TRANS/WP.29/633  
2 June 1998

**DRAFT SUPPLEMENT 9 TO REGULATION No. 75**

(Pneumatic tyres for motorcycles)

"Enveloping curve for centrifugal growth test"

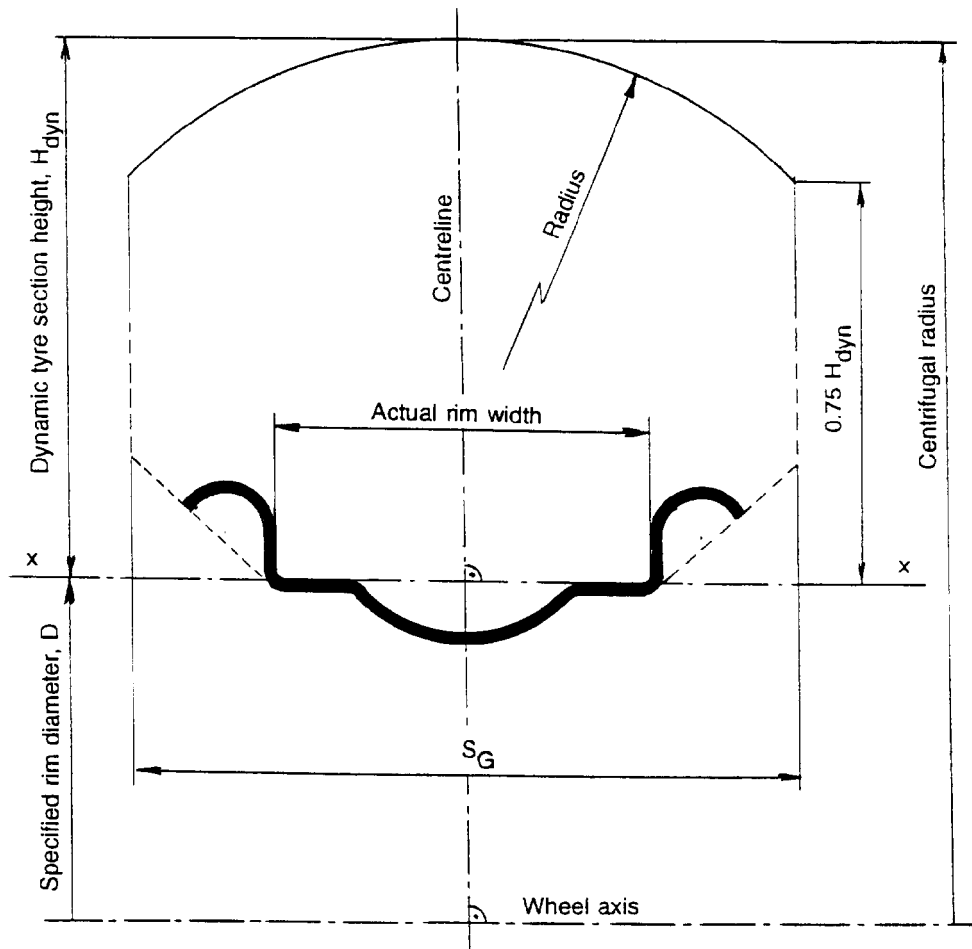
Annex 9, paragraph 4.1., replace the example drawing by the following:

$S_G$  = Maximum overall width in service  
 (This changes 1 mm per 0.1 Rim width code change from the measuring rim)

$H_{dyn}$  = Centrifugal radius -  $D/2$ .
